New Goddard School 193 Central Avenue, Milton, Massachusetts

**APPLICATION TO AMEND SITE PLAN APPROVAL dated July 23, 2020
193 Central Avenue, Milton**

AMENDMENT APPLICATION: Application to Amend Site Plan for 193 Central Avenue, Milton
(New building) dated 9.24.2021

SITE PLAN: "Site Plan, The Goddard School, 193 Central Avenue, Milton,
Massachusetts", by Williams & Sparages, 189 North Main Street,
Suite 101, Middleton, MA 01949 dated 9.7.2021

SITE PLAN
(3 of 13)

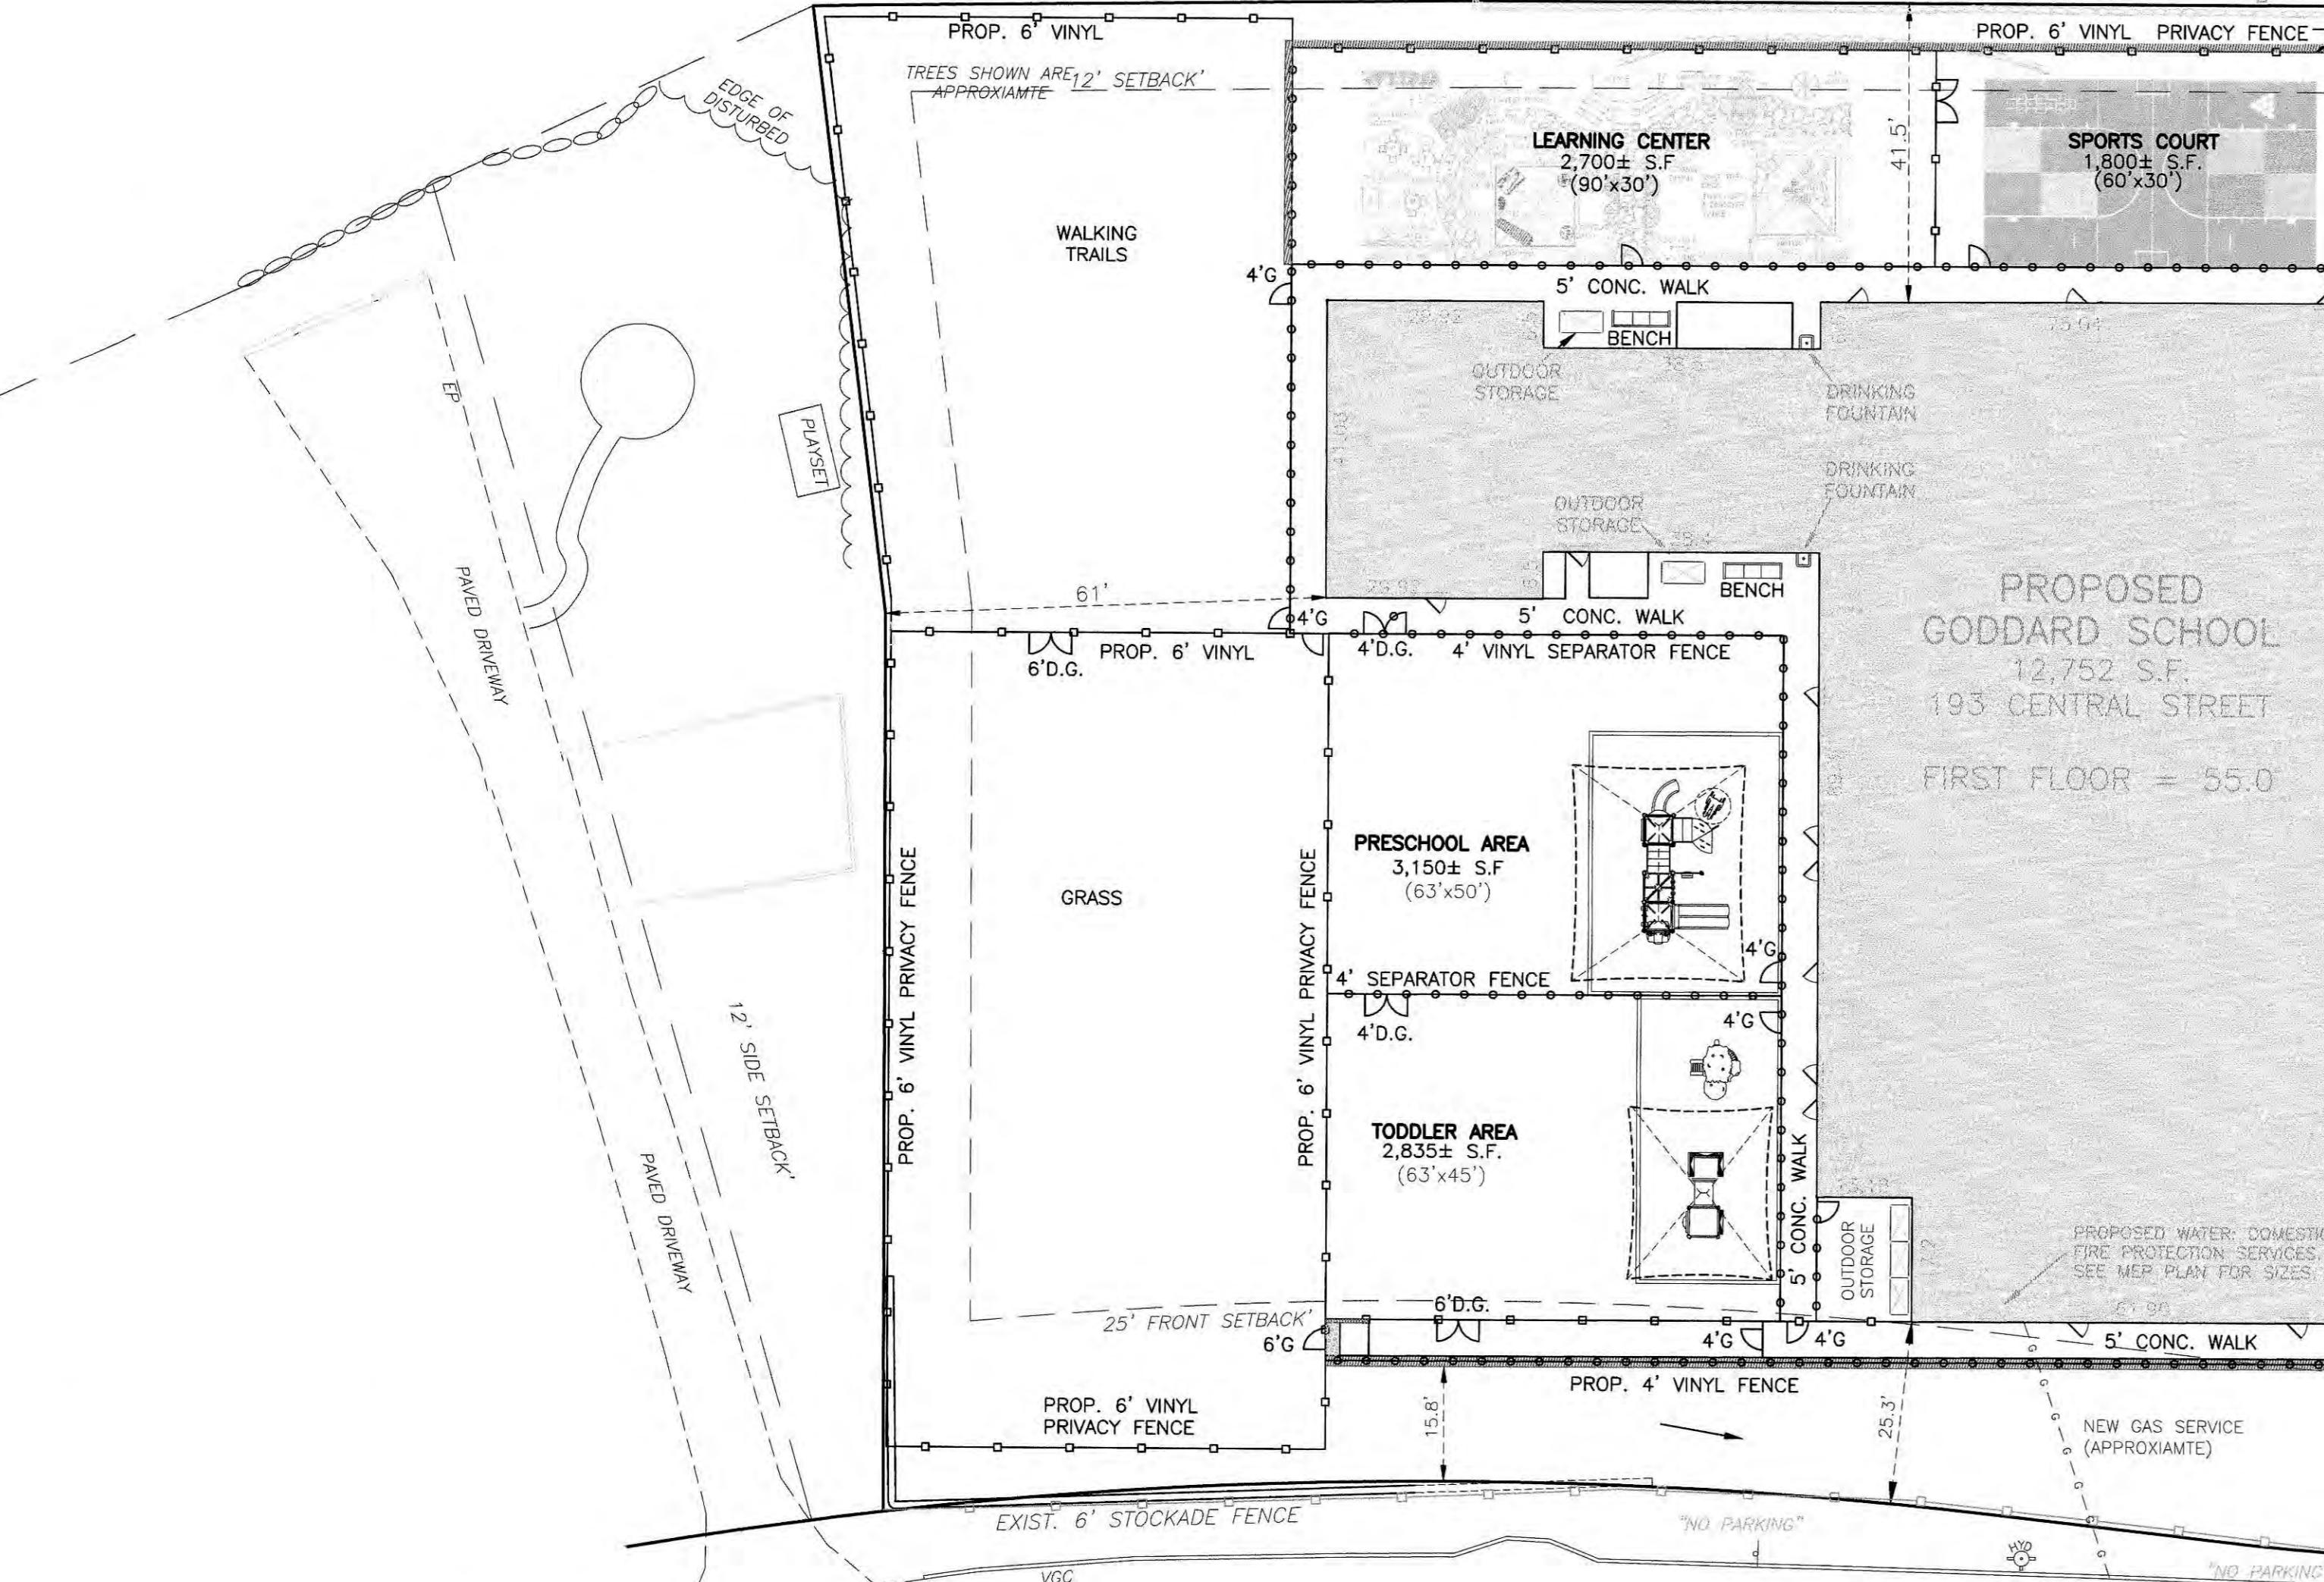
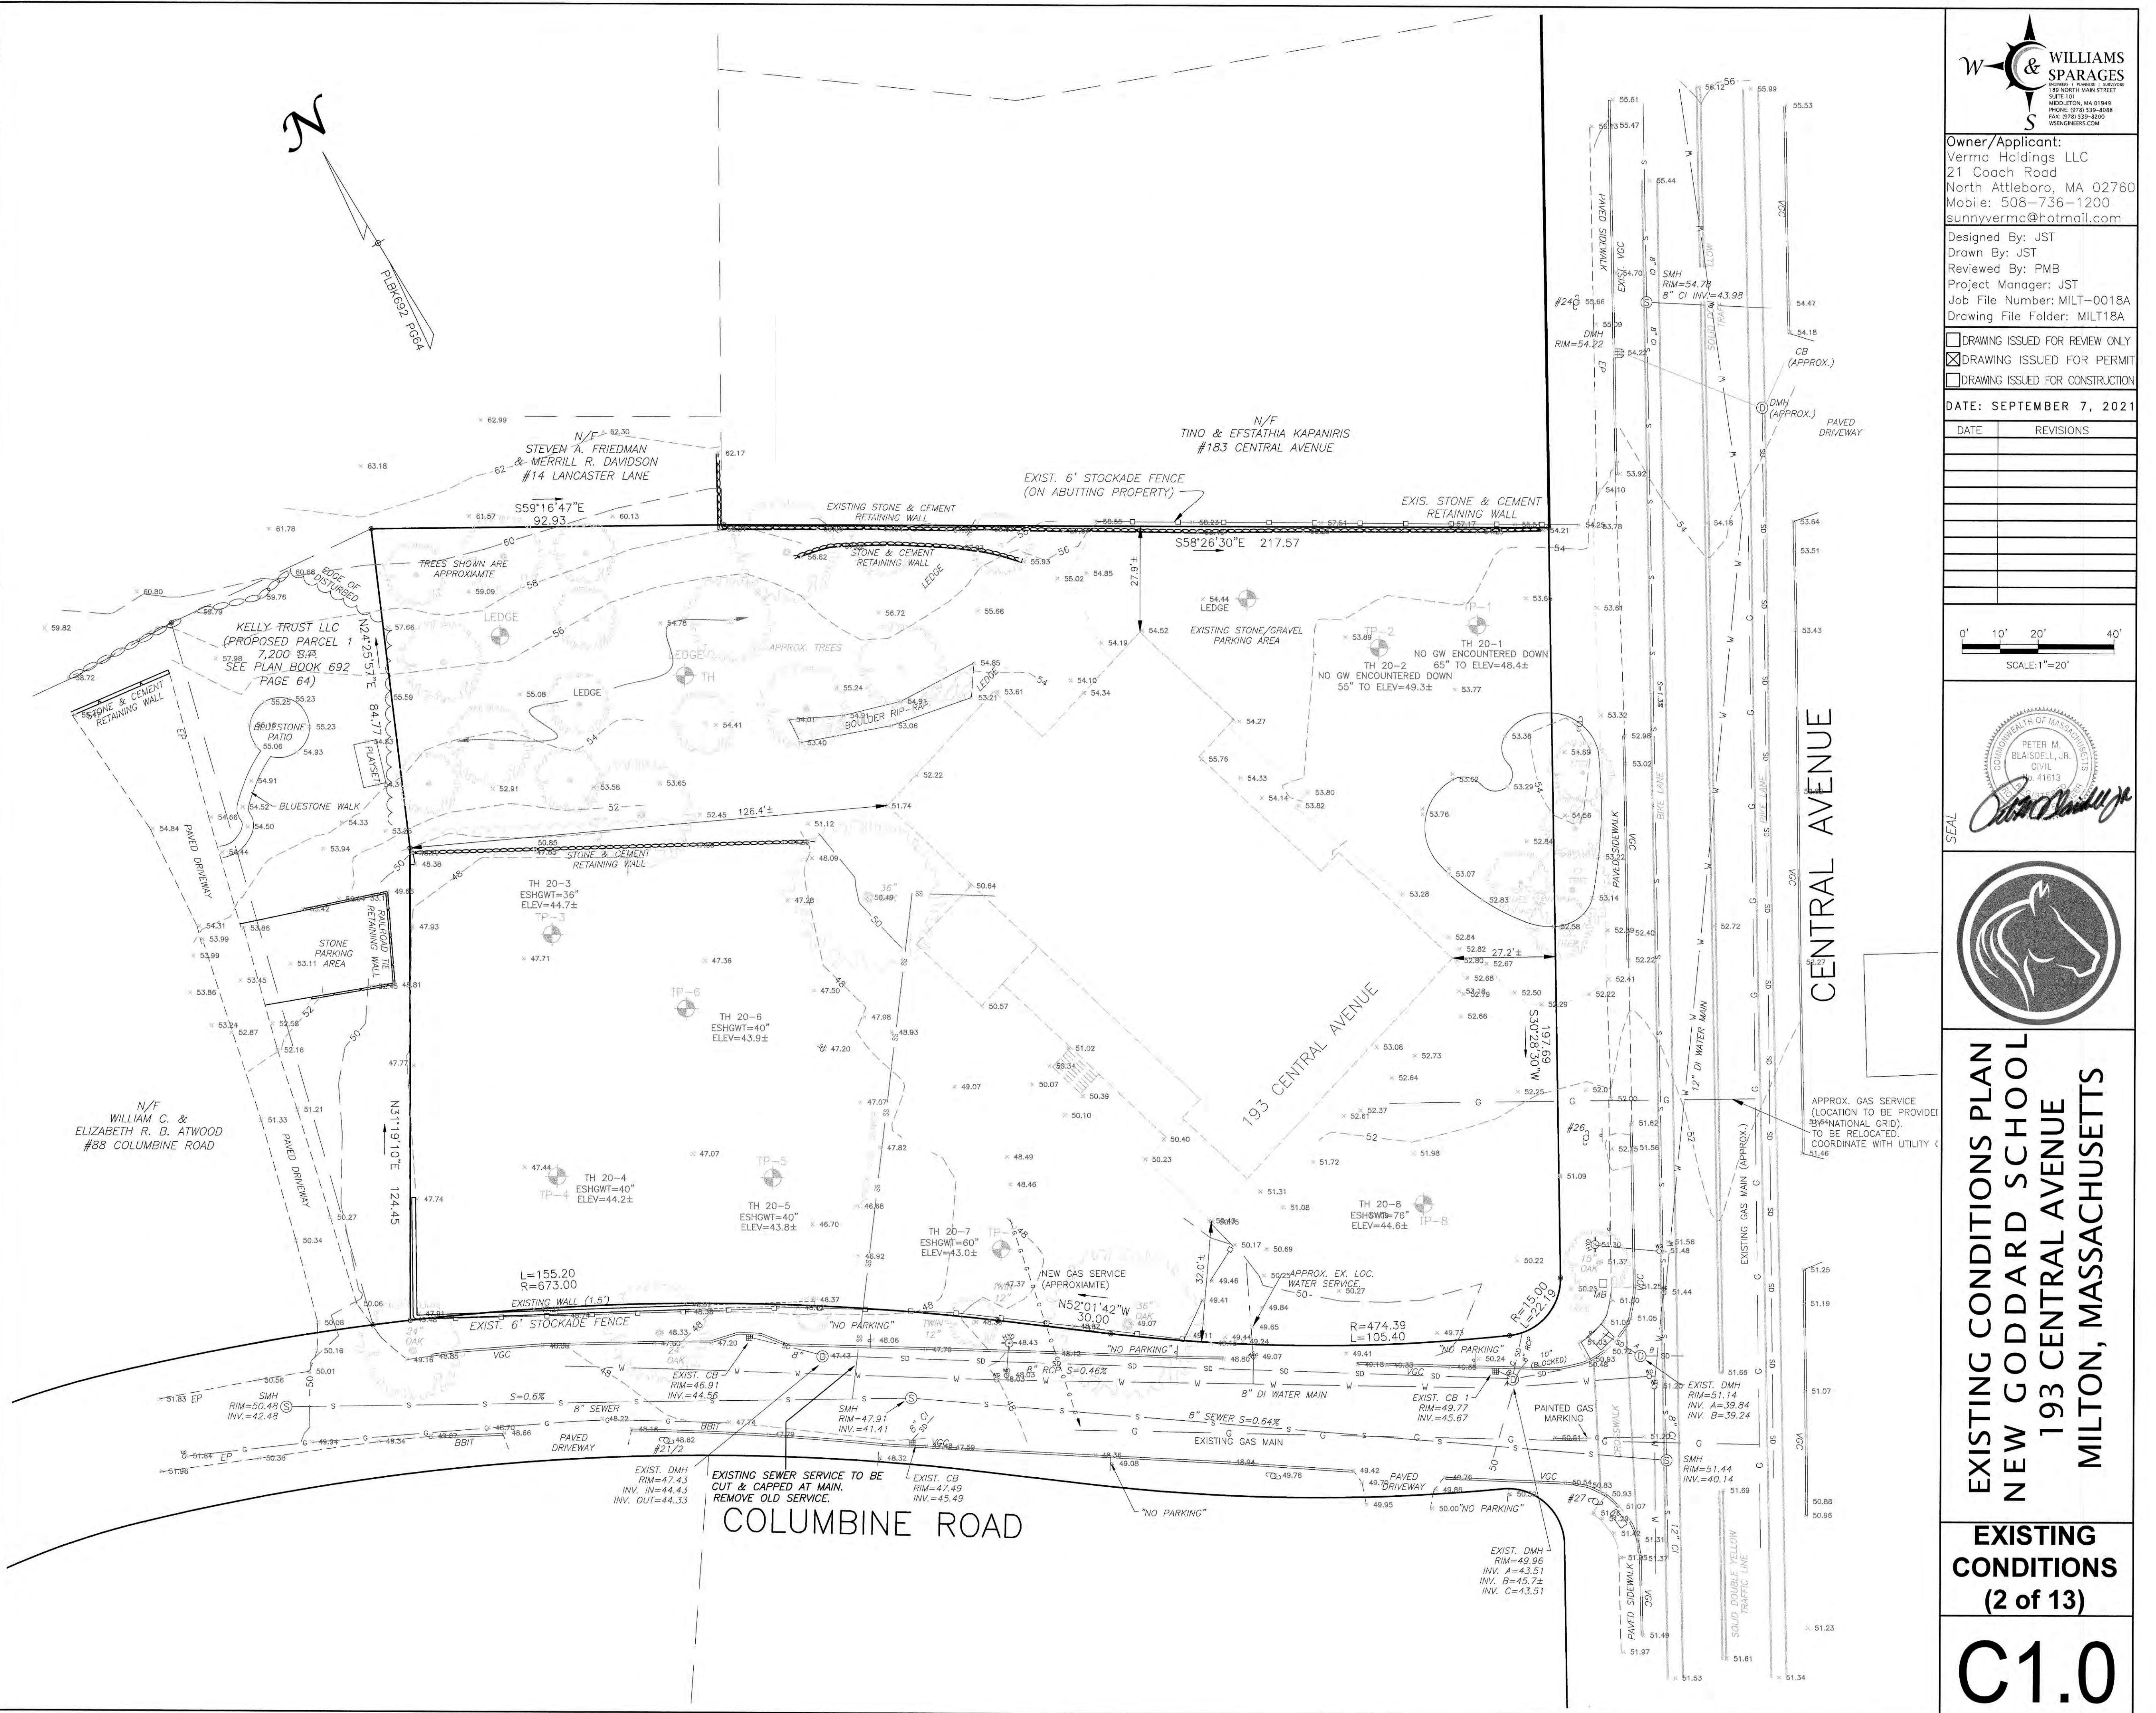
Because this plan is for a new building, parking must comply with parking setback requirements; the 15 side rear parking spaces must be moved to the front. The wooded area to the rear still remains as is. The front parking must now be set back 25 feet from the street and within that setback screening must be provided. The front parking area has 31 parking spaces including the required number of handicapped parking spaces.
14. **PARKING ACCESS DESIGN:** Last year the parking design called for the entrance and exit in one location, on the right as you face the building (with your back to Central Avenue). The circular driveway from Columbine Road remained as additional emergency access.

In this revised plan the applicant proposes a continuous parking area; the circular driveway is not included; and there is a separate entrance and exit for the parking area. This plan reverses an earlier plan after meeting with neighbors, so that now, cars enter closer to Columbine Road and exit on the other side. This layout locates the exit where there is no residence directly across the street.

STONE WALL CONCEPT

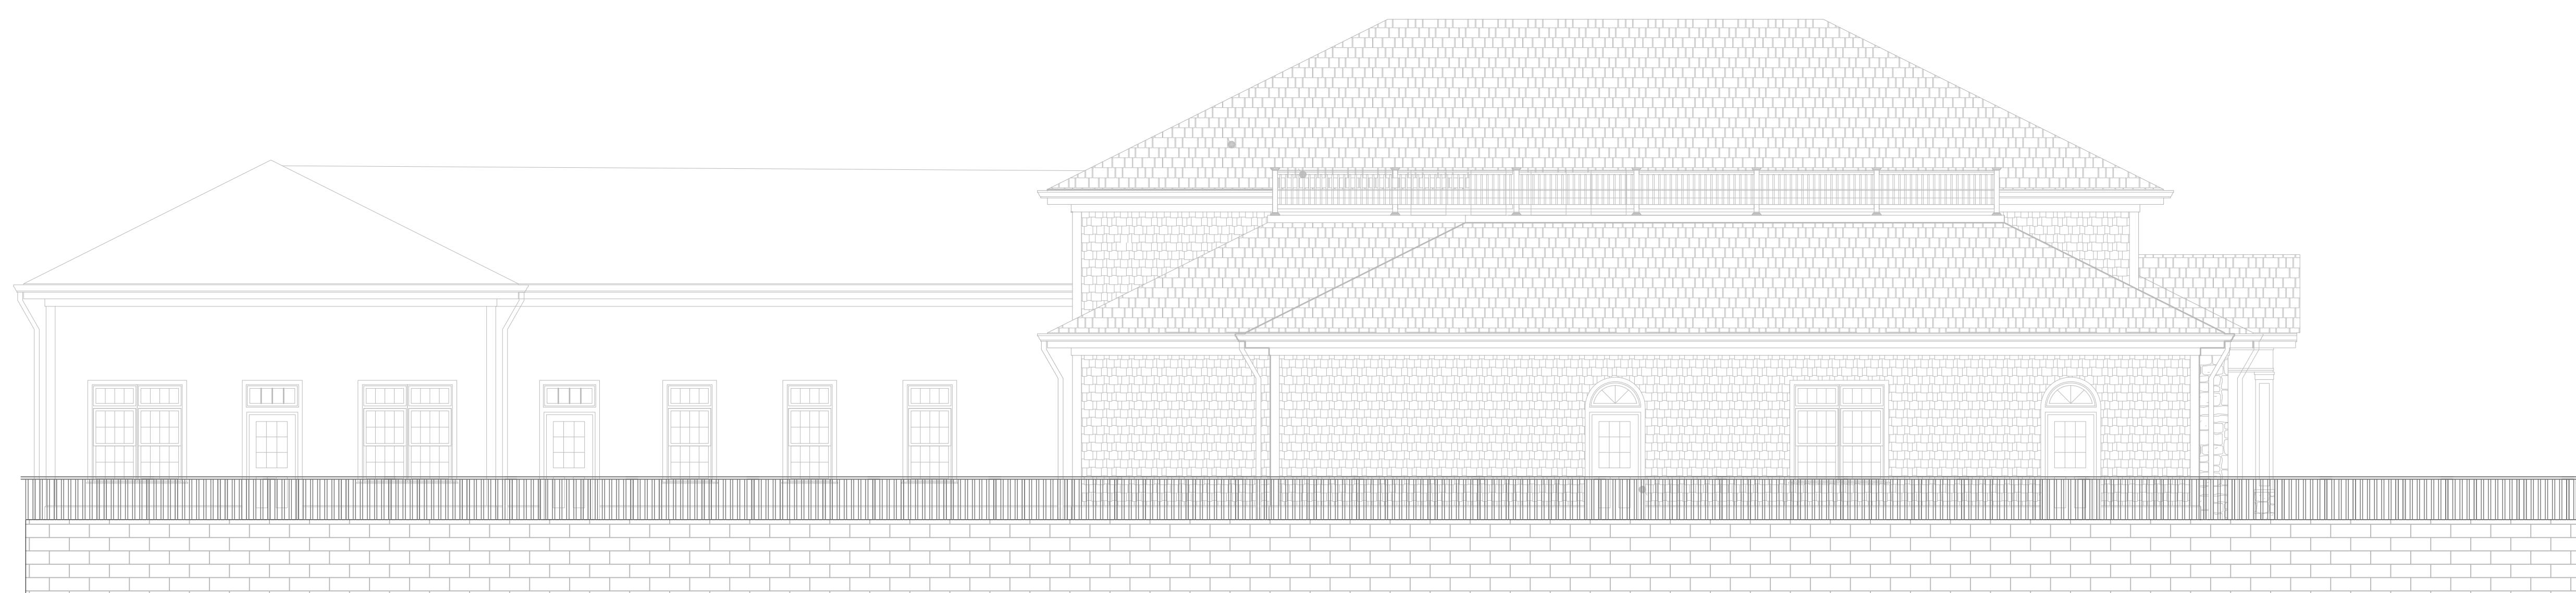
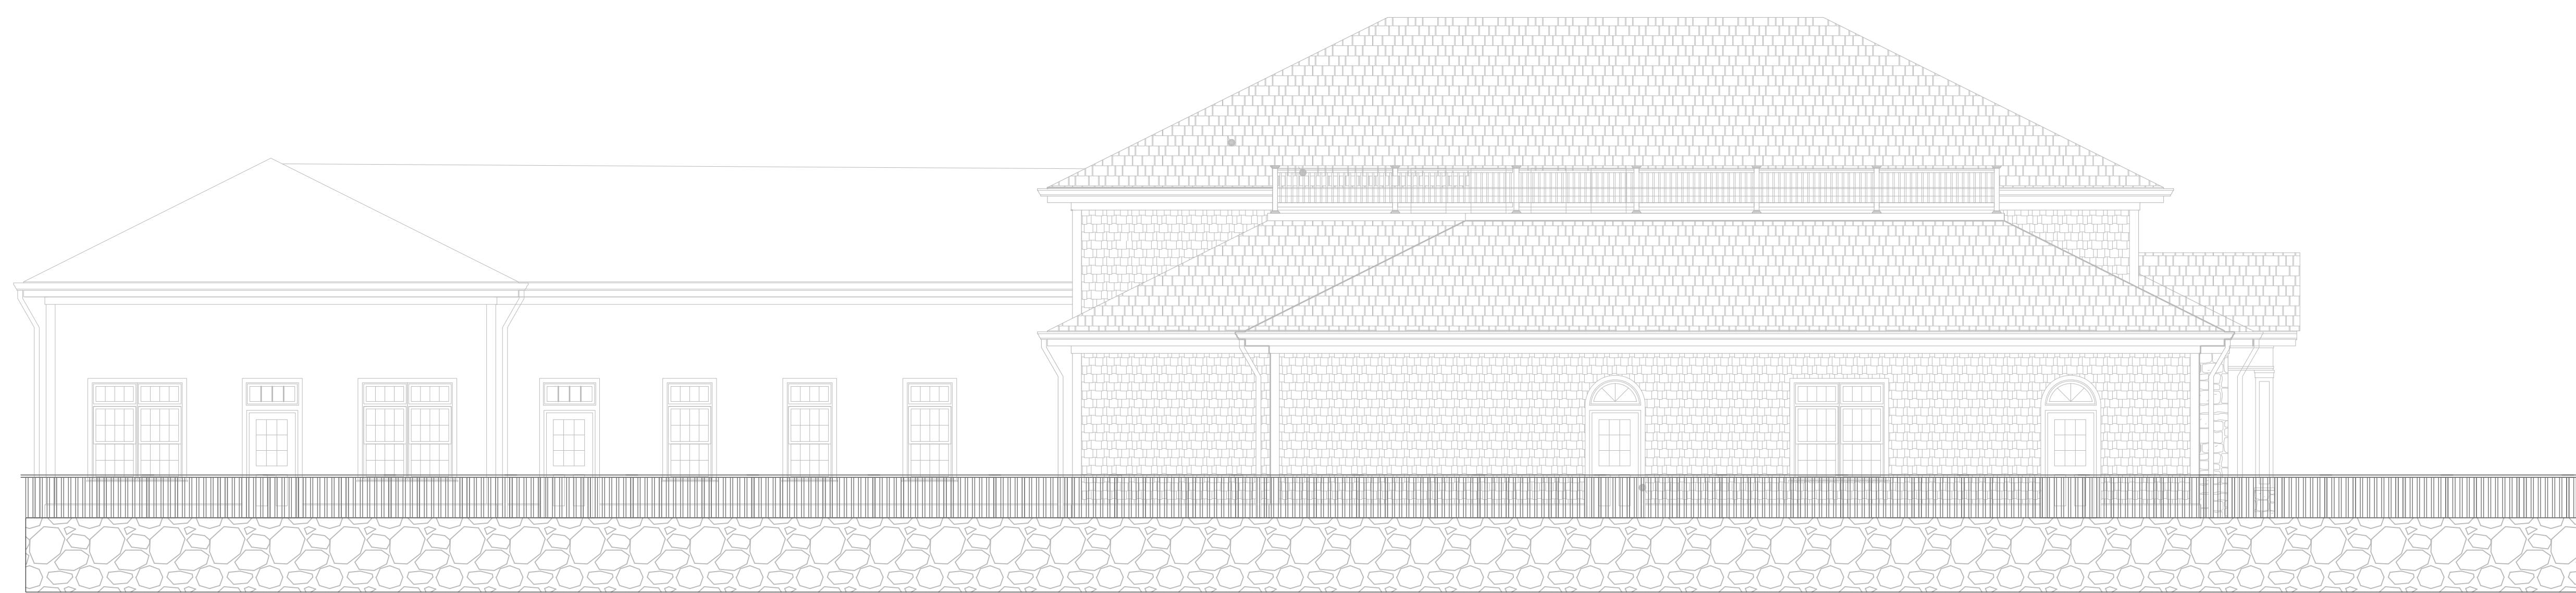
17. NEW STONE WALL ON COLUMBINE ROAD SIDE: A wall faced with stone is added to this side from the beginning of the side pathway to the back of the rear playground. This is a code requirement to protect children if a car loses control and goes off the roadway. The design is proposed to be faced with stone and to have fencing matching the perimeter fencing at the top of the wall. The wall will also shield the view and muffle sound towards Columbine Road. Exhibit F shows design suggestions.
